National Highways Planning Response (HEPR 16-01)

Formal Recommendation to an Application for Planning Permission

Council's Reference: LCC/2021/0007

Referring to the notification of a planning consultation dated 16th February 2021 for the prior extraction of sand / gravel and subsequent restoration with inert engineering fill to facilitate a platform for employment development or agriculture with peripheral landscaping on land north of the A674 Millennium Way, north east of M61 Junction 8 at Chorley, National Highways' formal recommendation is that we:

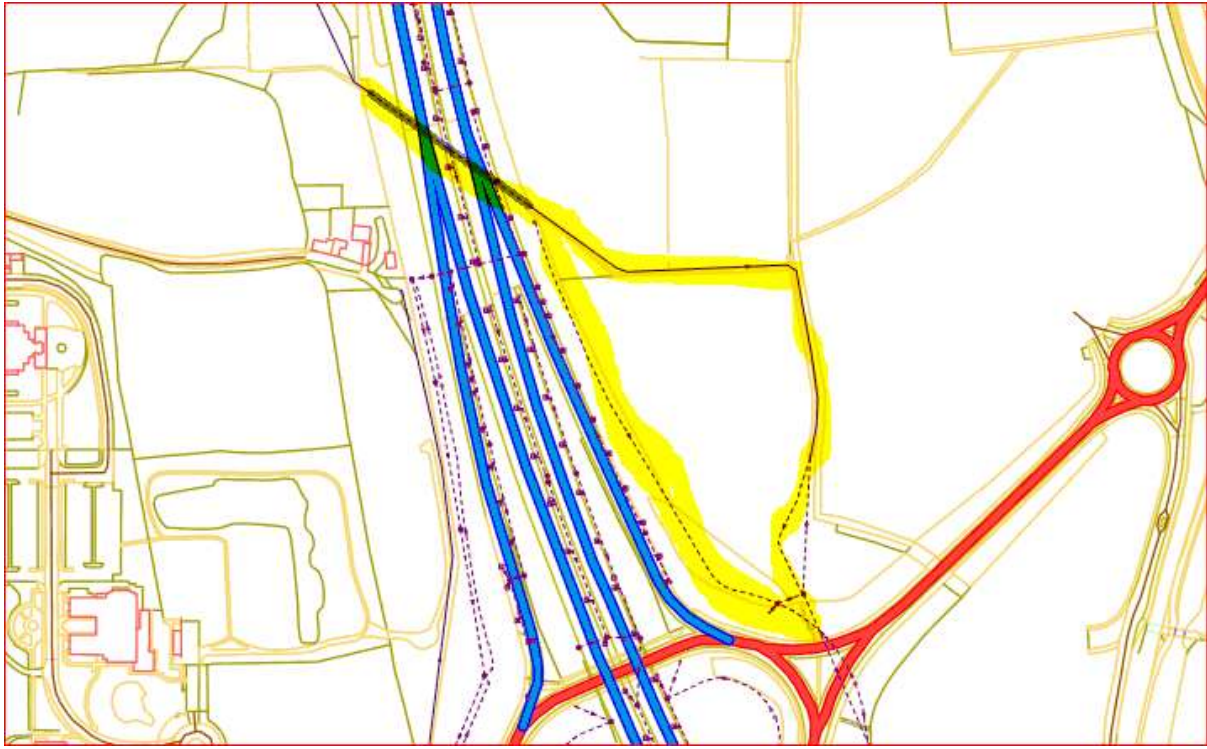
A motorway filter drain runs along the motorway boundary with this site at the foot of the motorway embankment., as shown in the drawing below. **Again, there will need to be a level of standoff agreed with National Highways from the excavation to ensure that this drain is not disturbed.**
